UNITED STATES PATENT AND TRADEMARK OFFICE

10/734,678

Office Action Summary	Application No. 10/734,678	Applicant(s) WOMACK ET AL.	
	Examiner Stephen Gordon	Art Unit 3612

marked up figure for 10/734,678
Attachment to F&O

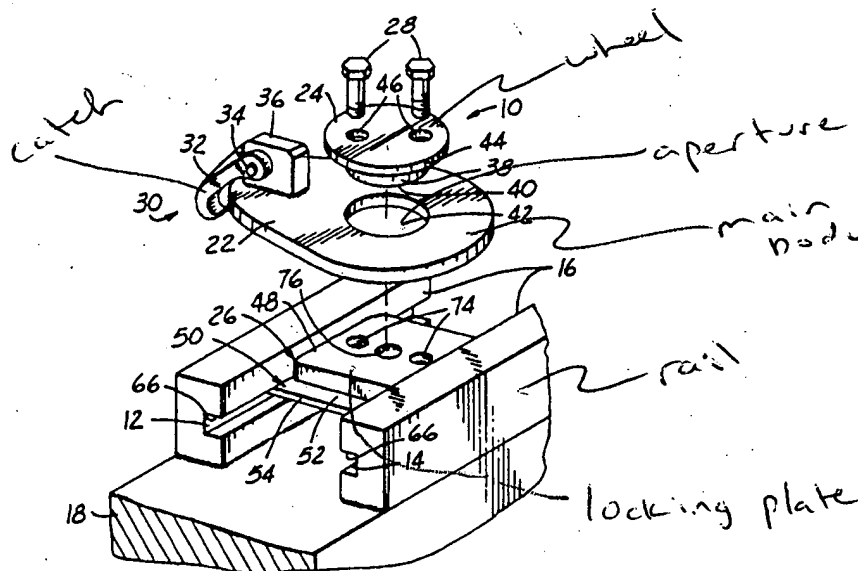
Claim 16, see marked up copy of cover page figure of Nilsson 4,915,342 attached to this action.
